Access Compliance Report Public Rights-of-Way (Curb Ramps)

Main Street: S_GILBERT_ST Cross Street: STONYBROOK_DR Location: SW

ADA ID: RPRK210927142732 Ramp Type: Type 1 - Perpendicular Diagonal Initial Pass/Fail: Fail Overall Compliance: No Severity Score: 32

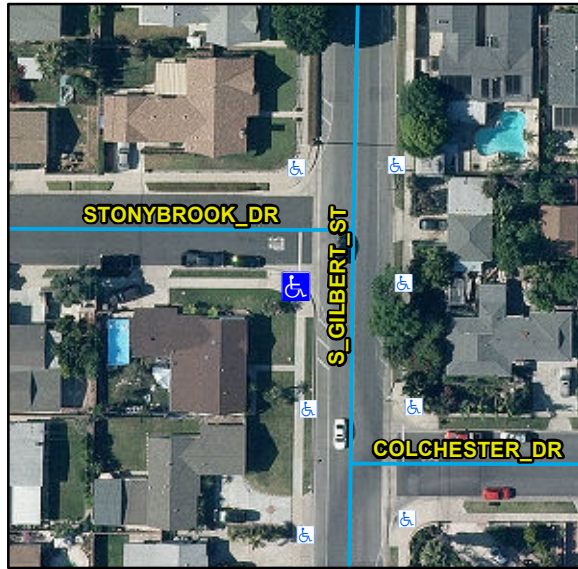
R304.2.2, R204.3, R304.5.3, STD 1115

Remove & Replace Curb Ramp With Two New Directional Ramps or Equivalent.
